Title Telink-Semi		
Size A	Document Number C1T139A3	Rev V4.0
Date:	Tuesday, July 13, 2021	Sheet 1 of 2

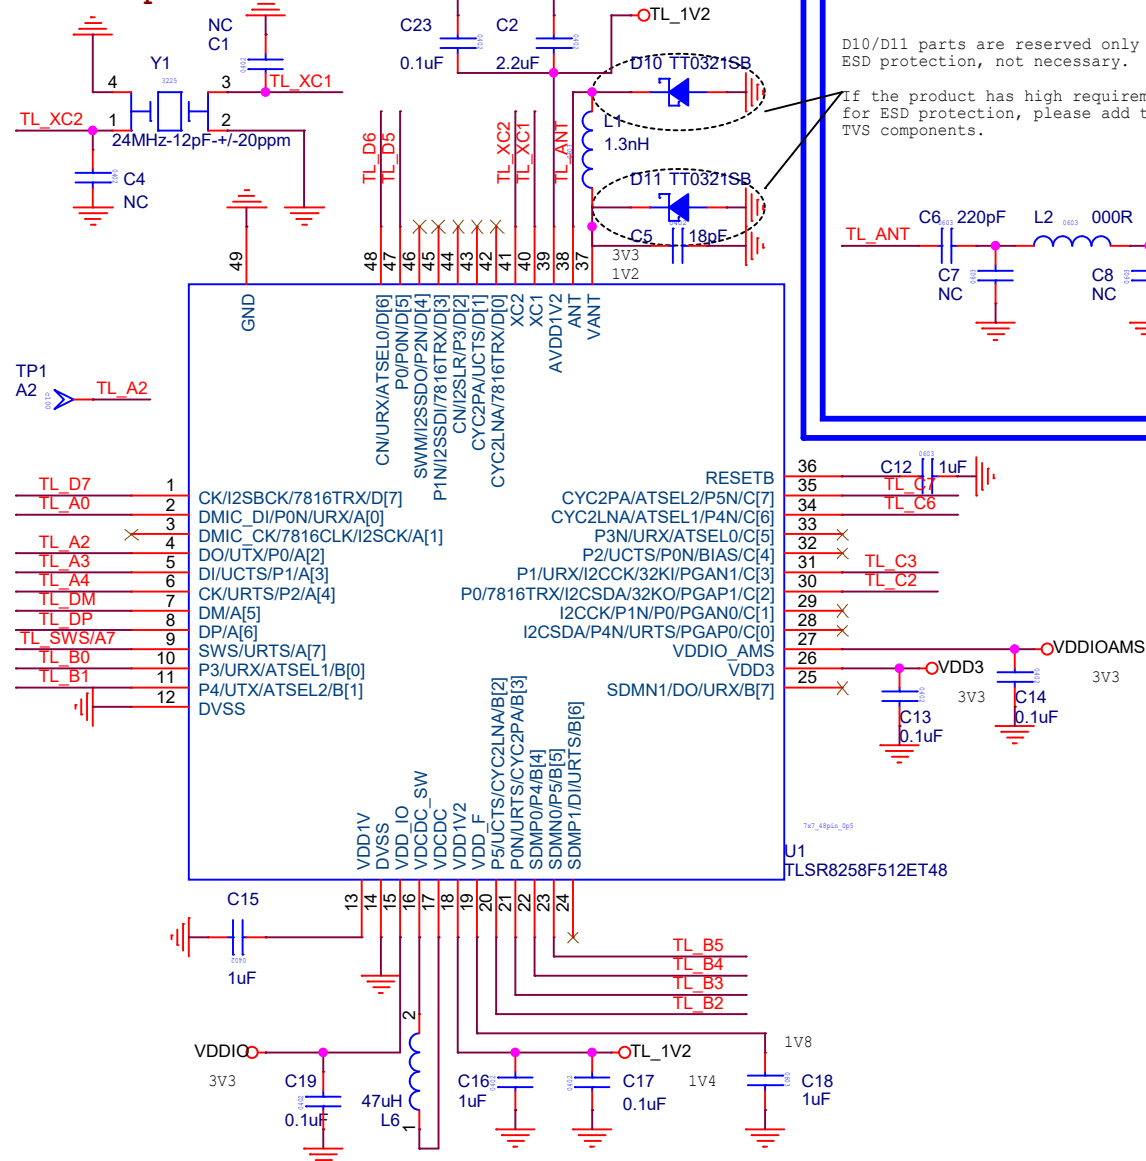
Date	Version	Update
2018-11-13	v1.0	update C9/C10/C11/L3/L4/L5 value
2018-11-30	v1.0	update C11/L4 value
2018-12-3	v1.0A	change antenna length
2019-02-26	v1.0A	update C9/C10/L3/L4 value
2019-08-13	V4.0	PA chip is changed to RF2401 C9=1.8pF L3=2.2nH C10=1.5pF L4=3.3nH C11=0.5pF
2020-06-04	V4.0	PA chip is changed to GC1101 C9=1.8pF L3=2.4nH C10=1.8pF L4=0R C11=NC
2021-07-13	V4.0	Add TVS diode TT0321SB to the RF pin, PCB is not updated

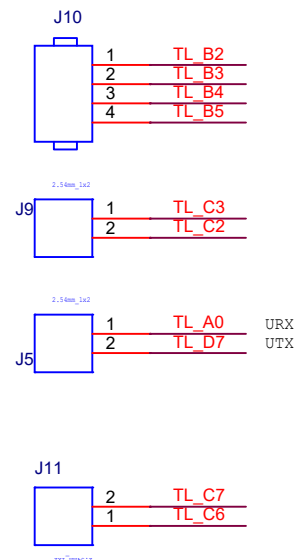
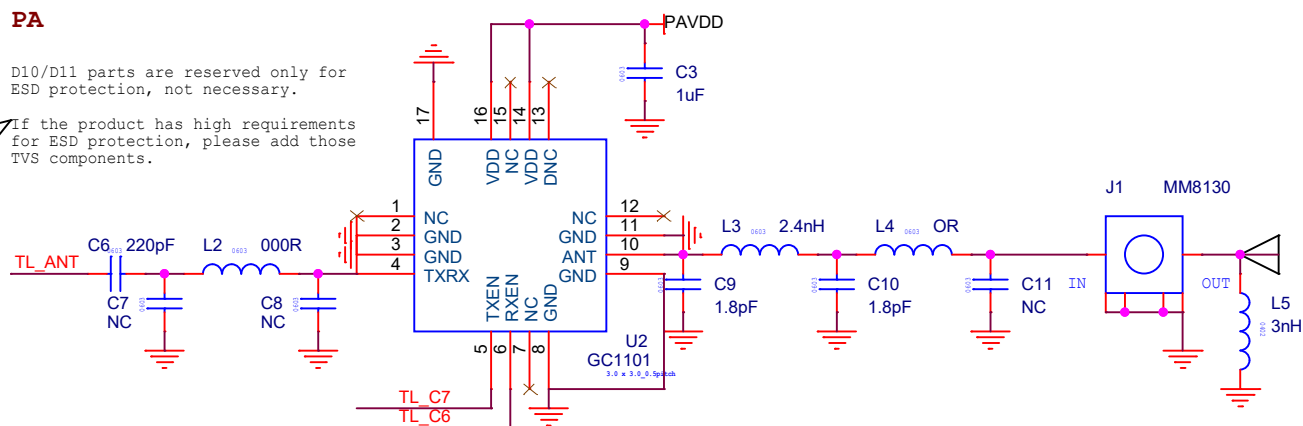
D10/D11 parts are reserved only for ESD protection, not necessary.

✓ If the product has high requirements for ESD protection, please add those TVS components.
